**Amendments to the Code of Practice for Structural Use of Concrete 2013 (2020 Edition)**  
**( June 2023 )**

Amendments to the Code of Practice for Structural Use of Concrete 2013 (2020 Edition) in June 2023 included:

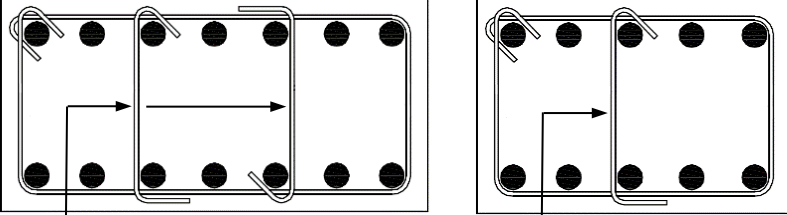
3. Clause 9.9.1.3(b) <sup>2</sup>	(b) Anchorage Links should be adequately anchored by means of hooks with bend not less than $135^\circ$ in accordance with clause 8.5. Anchorage by means of welded cross bars is not permitted. Where .....	(b) Anchorage Links should be adequately anchored by means of hooks with bend not less than $135^\circ$ in accordance with clause 8.5. <b>Alternatively, links/ties should be adequately anchored by means of hooks bent through an angle of not less than <math>135^\circ</math> at one end and <math>90^\circ</math> at the other end, and should be alternated end for end along the longitudinal bars (see Figure 9.6a).</b> Anchorage by means of welded cross bars is not permitted. Where .....

Item	Current version		Amendments	
4. Figure 9.6a			 <p data-bbox="1288 558 1724 630">Links/ties with alternated end for end along the longitudinal bars</p> <p data-bbox="1803 566 1993 598">Single link/tie</p> <p data-bbox="1276 662 2049 694">Figure 9.6a - Alternative arrangement for links/ties for beam</p>
